Request Summary

- Requesting approval of Final Development Plan, Design Review, Variances, Conditional Uses, and Rezoning for an apartment complex at the Crescent at Central Park
 - Mostly zoned L-MFRD – Multifamily Residential with Limited Overlay
 - Southern portion zoned SCPD – Select Commercial Planned District
- Rezoning, FDP, DR, CU, and Variances approved in 2020 and 2021
 - Rezoned from SCPD to L-MFRD
 - Current application for southern portion of site
 - The Conditional Uses allowed for increased density and building height, accessory buildings, and a flexible arrangement of buildings
 - CUs must be re-approved due to change in project boundaries/scope
 - The Variances were for signage and screening requirements
 - Most Variances must be re-approved due to change in project boundaries/scope

Elevations

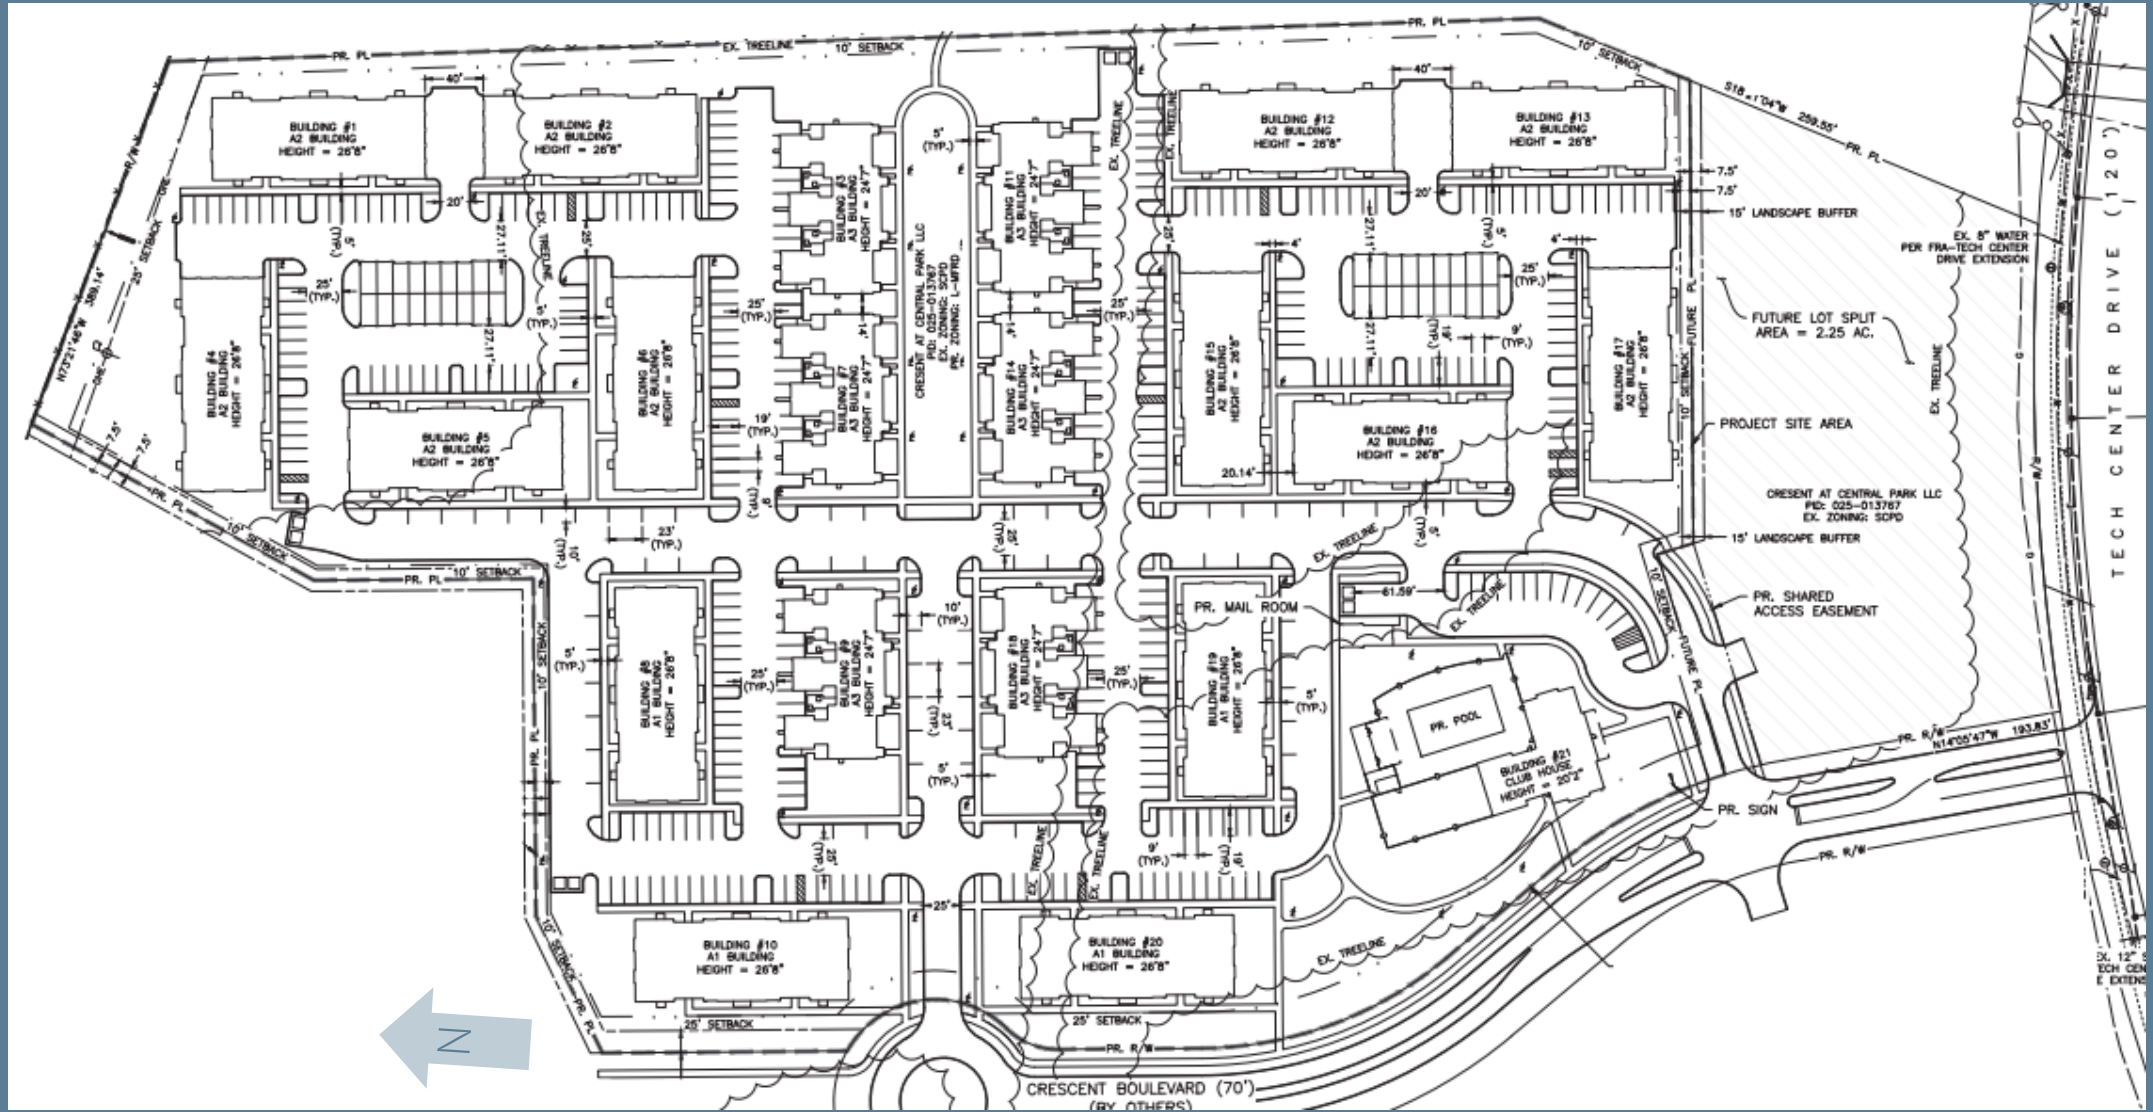
- Staff has no objection to the Design Review
 - Landscaping and materials meet DR requirements
 - Brick veneer, cast stone veneer, vinyl siding
 - Vinyl siding is permitted only if approved by Planning Commission
 - Code recommends “natural, historic, earthtones or similar colors”
 - Under purview of Planning Commission
- Staff recommends approval of the Final Development Plan
 - All applicable Code requirements are met with Variances
